Haywood Road Pedestrian & Bicycle Safety Audit

May 2011

Asheville Bicycle & Pedestrian Task Force

Haywood / Clingman / Roberts Roundabout

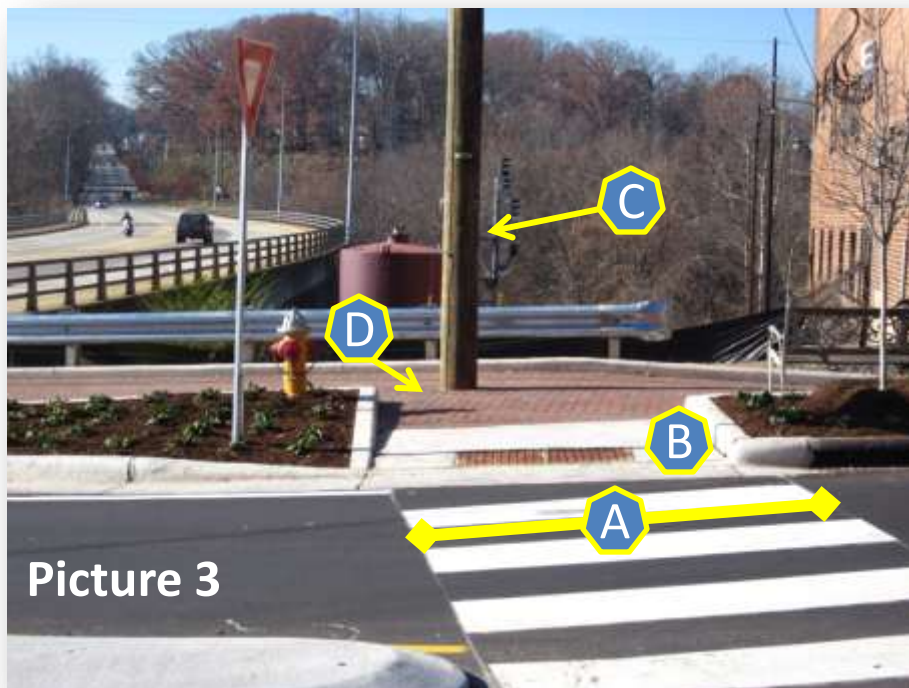
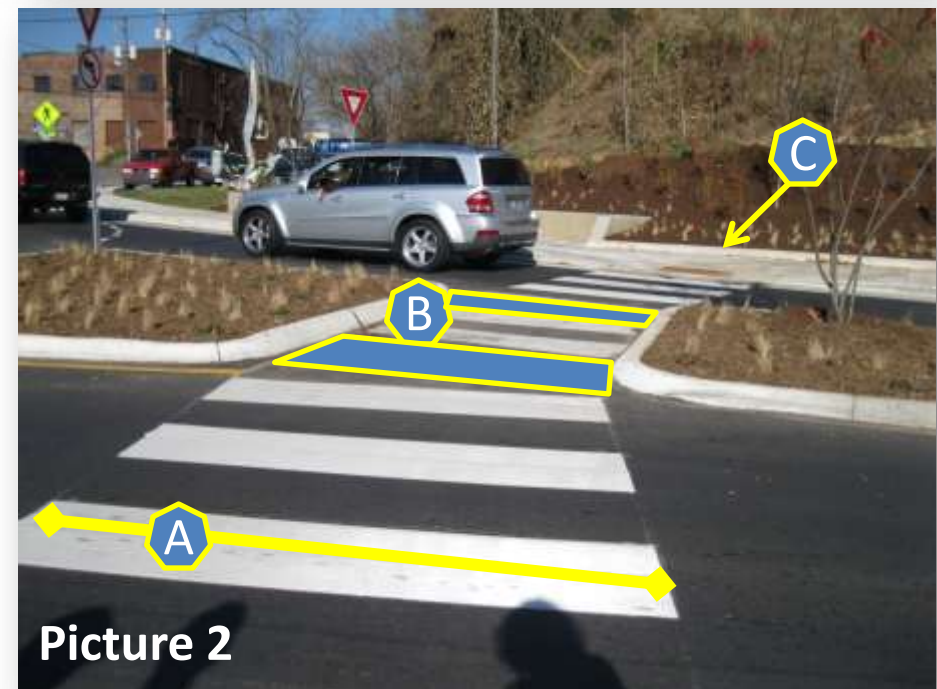
- No raised barrier between sidewalk and roundabout lanes for persons with low vision (*Picture 1*).
- ADA – crosswalk width, median design and curb ramp (*Picture 2*).
- Similar ADA design issues; utility pole in middle of shared ped/bike facility and inadequate clearance width (*Picture 3*).

Beverly Road/ Ridgelawn Road Intersection

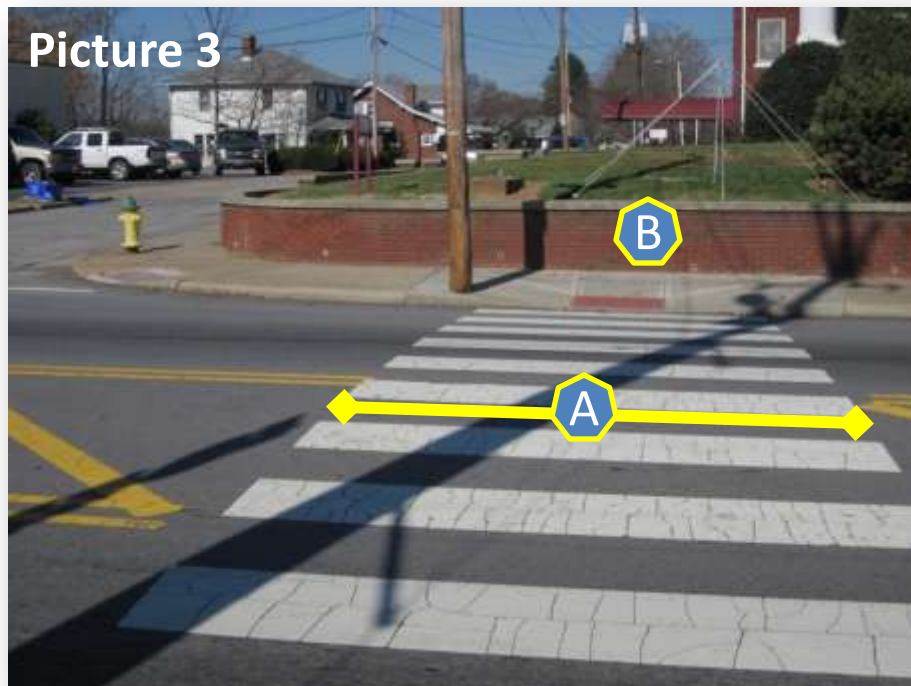
- Confusing intersection for all users (*Picture 1*).
- No crosswalks or signage for safe crossing (*Picture 2*).
- Proposed improvements by NCDOT – no bike lanes/sharrows; little consideration other than cars, such as children walking to school (*Picture 3*).

Vermont Avenue / Sand Hill Road Intersection

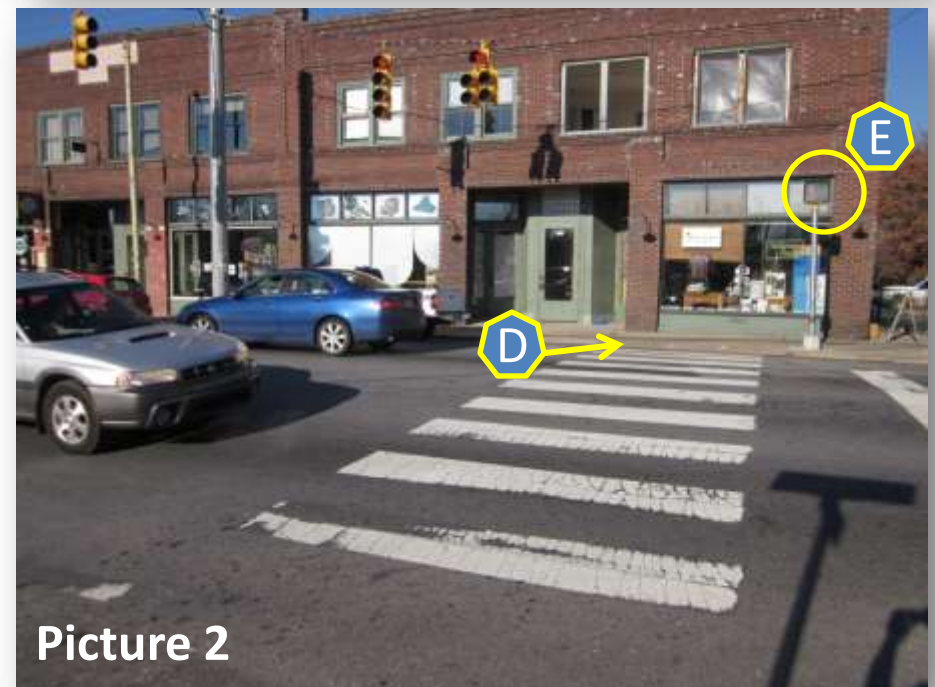
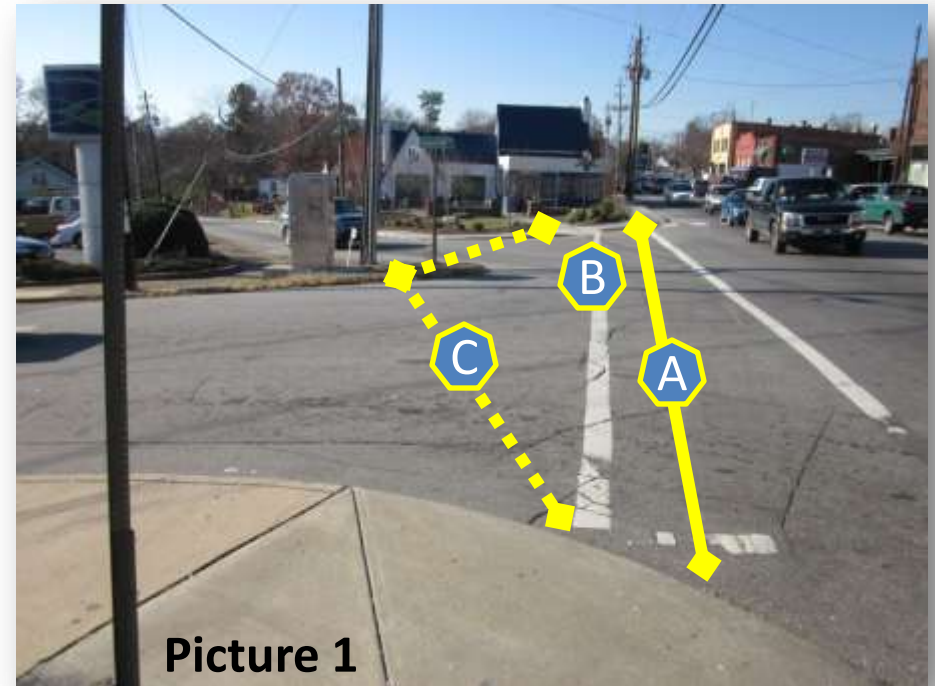
- **Picture 1, A:** Excessive length and confusing alignment for a three-way intersection with split phasing.
- **Picture 1, B:** Potential solutions include installation of refuge area, which would also calm traffic but could present turning radius issues for larger vehicles (although there are limited trucks). Or....
- **Picture 1, C:** Reconfigure crosswalk for staged crossing of the two legs.
- **Picture 2, D:** Receiving ramp does not meet ADA standards.
- **Picture 2, E:** Pedestrian signal placements blends with windows on far-side building. This can create visibility problems for children or person with poor vision.

Miscellaneous Observations

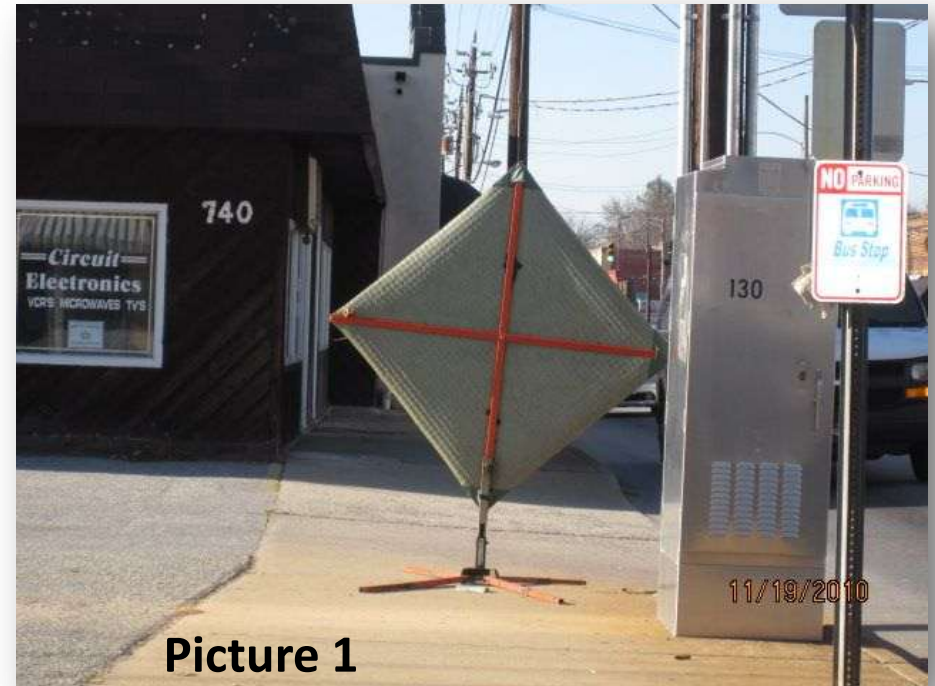
- Placement of temporary traffic signs block pedestrian way (*Picture 1*).
- Vehicles on open driveway cuts parked within pedestrian zone (*Picture 2*).
- The lighting along the entire Haywood Road corridor is considered “highway scale”, not pedestrian scale (*Picture 3*).
